Memo

**Subject Clarifications Regarding Special-Status Aquatic Invertebrates for the
Proposed Creekside Memorial Park, Corrie Development Corp., Contra
Costa County, California.**

USFWS COMMENTS ON DEIR

**Potential Aquatic Invertebrate Habitat On Site
 Creekside Memorial Park
 Corrie Development Corporation
 Tasajara Valley, Contra Costa County, California**

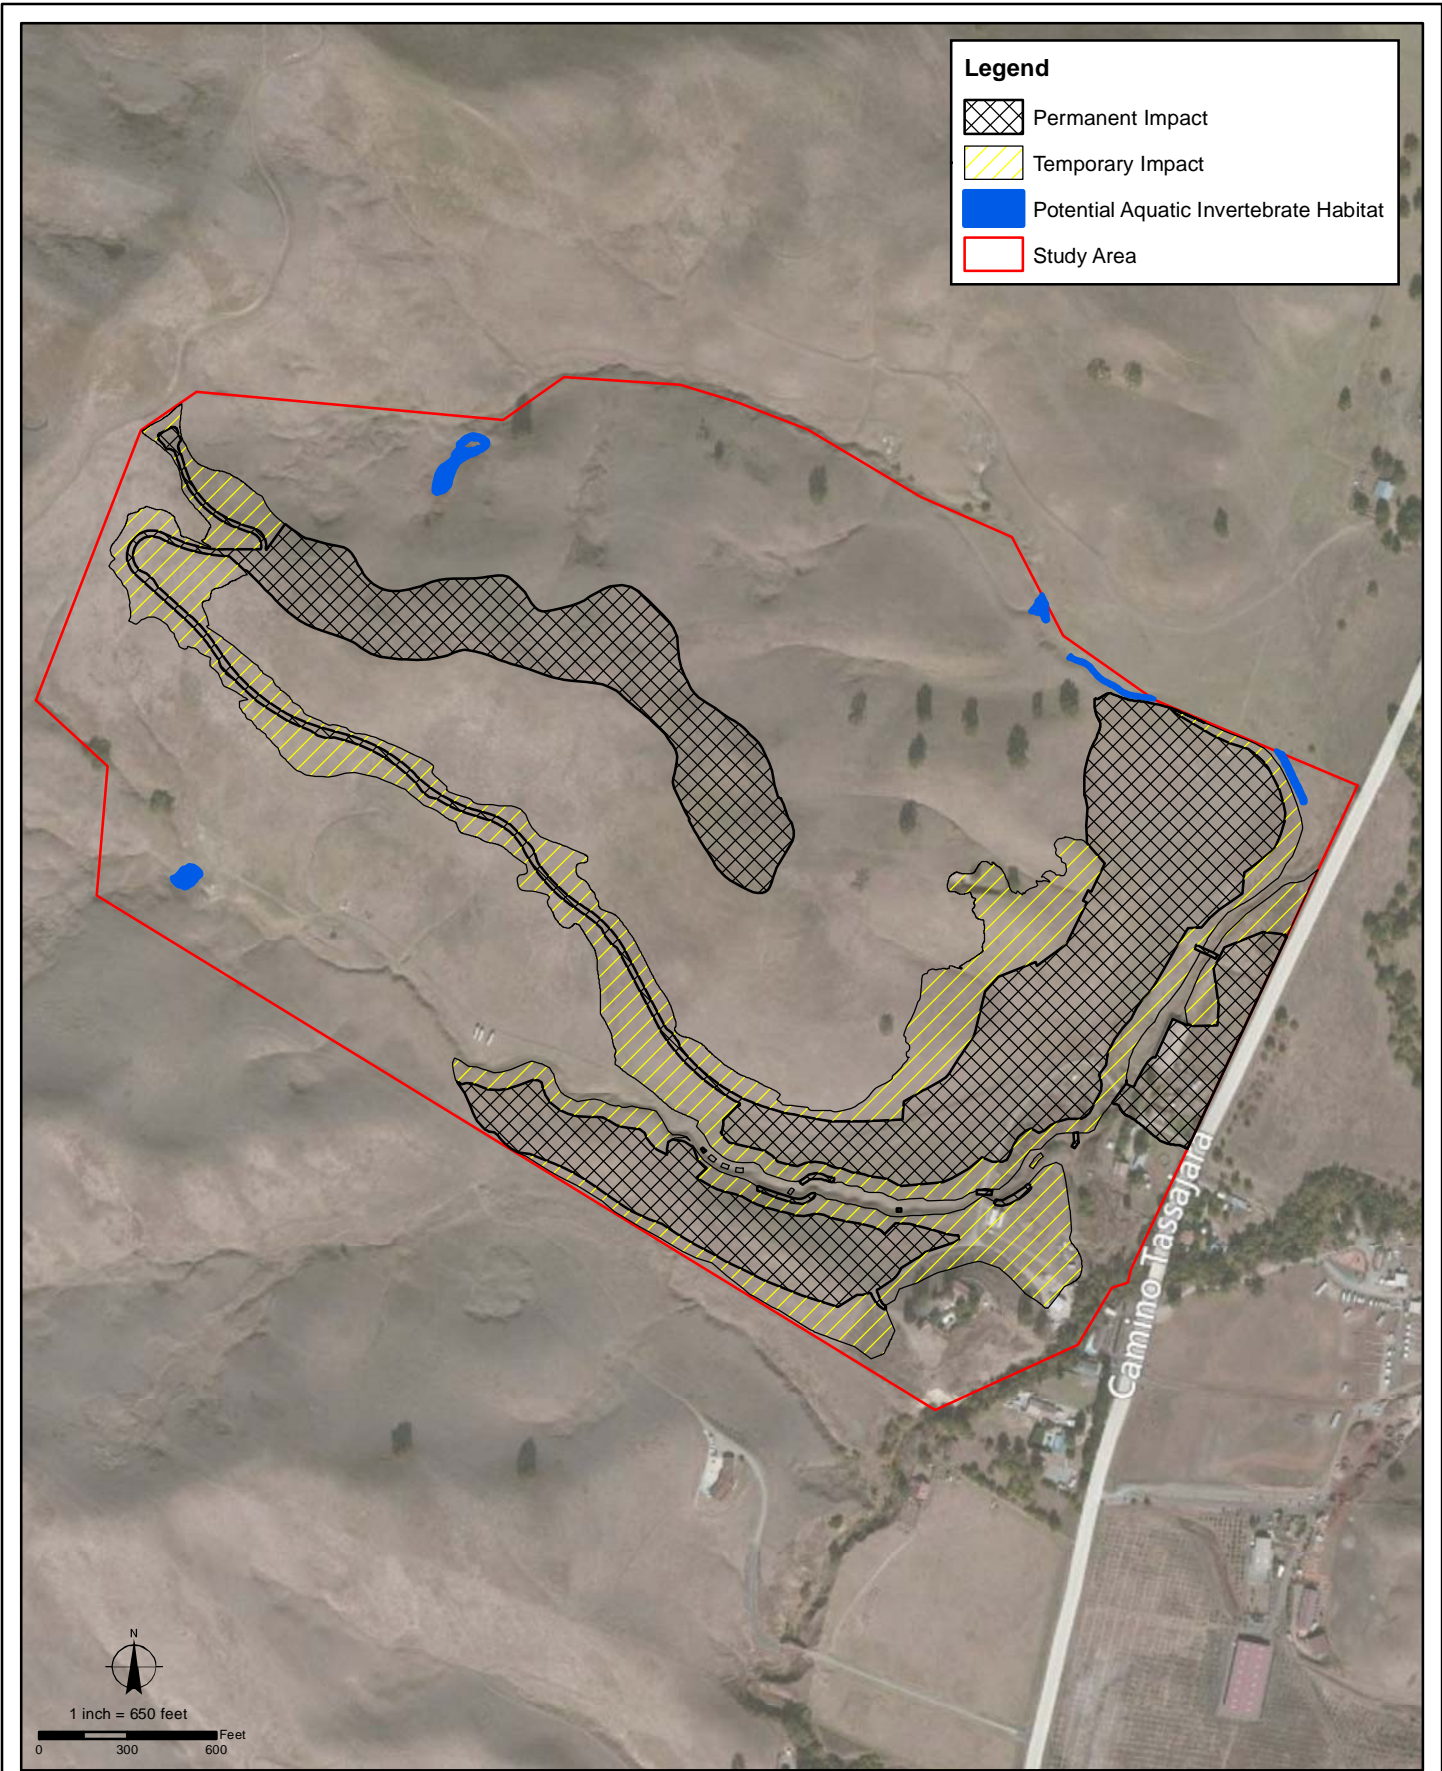
- 1) It is unclear how the suitable habitat for listed crustaceans will be avoided.
- 2) A low potential for listed crustaceans to occur is asserted without supporting documentation. Surveys were not conducted.
- 3) The distance of construction from aquatic features is not stated.
- 4) Irrigation runoff may affect water quality, an indirect effect that may result in take of listed species.

Points 1 and 3 of the Service comments are somewhat related. As discussed during an on-site meeting on 12 June 2008 with Service biologists Kim Squires and Michelle Havens, the site planners P/A Design Resources, Inc. worked closely with the project biologist to minimize impacts to aquatic features. No construction is planned for the immediate areas containing the two seasonal depressions or the ponds, although some maintenance is planned for the ponds. As discussed in the meeting of 12 June 2008, a breached weir on Pond 1 on the southwest side of the property will be reinforced with rock and compacted soil, which avoids excavation and reconstruction of the pond. This is desirable in order to avoid downstream sedimentation. Pond 1 is over 900 feet from proposed lawn entombment areas, and about 500 feet from grading for the upper garden access road. Pond 2 on the northwest side of the property is experiencing some erosion at its outflow, and this would be stabilized by planting suitable native riparian vegetation. Pond 2 is located about 450 feet from proposed lawn entombment areas in the upper garden. No direct action is planned for the areas around the two seasonal depressions, and each of

these will be 100 feet from proposed grading for the lower garden based on the setback requirements of Mitigation Measure 3.4-2d in the DEIR (page 3.4-45). This measure (provided below) requires a 100 foot grading setback from the seasonal depressions that provide potential habitat along the northern property boundary:

Figure 2 depicts the permanent and temporary impact area in relation to potential special-status invertebrate habitat. Also, as stated in DEIR Mitigation Measure 3.4-2c (p. 3.4-43-45) the limits of construction will be clearly delineated in the field prior to construction activities, with exclusion fencing to be utilized to demarcate the potential habitat areas. The contractor will also be prohibited from placing or storing equipment, from dumping, burning or burying any rubbish, waste or fill materials, and from using pesticides or other toxic chemicals in the potential habitat.
